# SITE PLAN

**Reviewed for Code Compliance**  
 Approved by: Brandon Zipser  
 Permit #: **541-21-000119-STR**  
 Date: **04/15/2021**  
 Reviewed for Lincoln City

SITE PLAN  
6600 LOGAN RD.  
LINCOLN CITY, OREGON  
SCALE: 1" = 20.00'

2400 PLAN  
 6600 LOGAN RD.  
 LINCOLN CITY, OREGON

LAYOUT SCALE: 1/4" = 1'

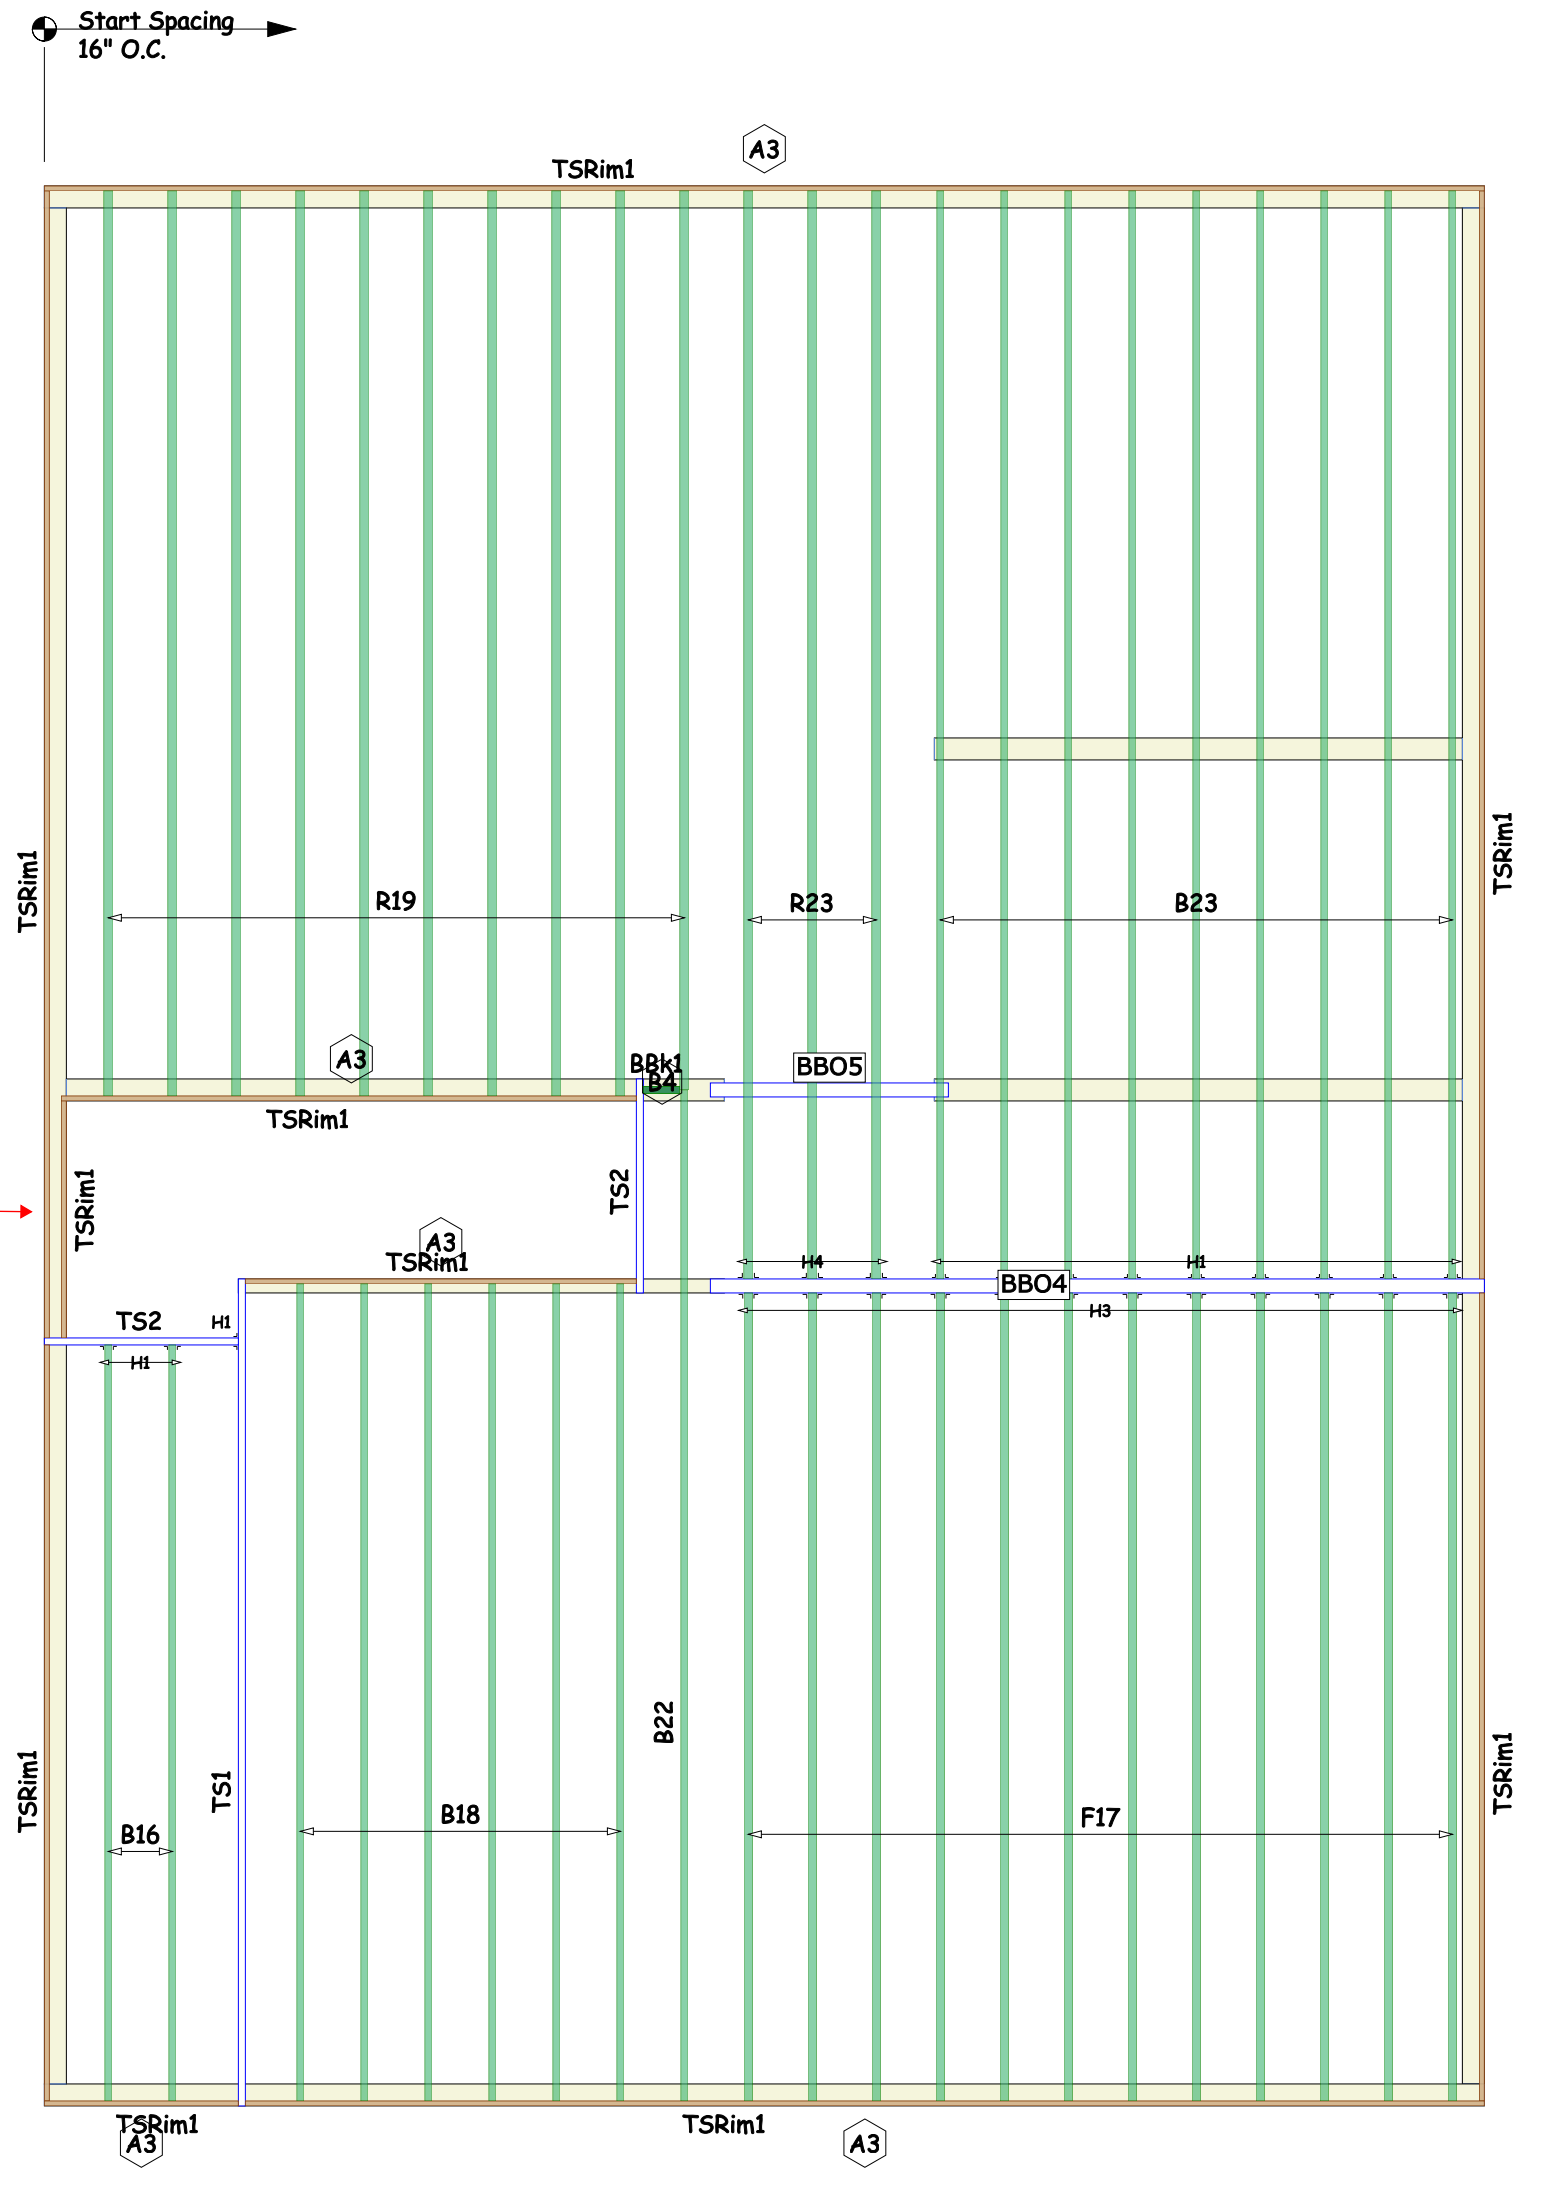
Balloon frame exterior walls of all open areas, stair wells and vaulted gable end walls.

Squash block all point loads through floors to the foundation/approved footings below.
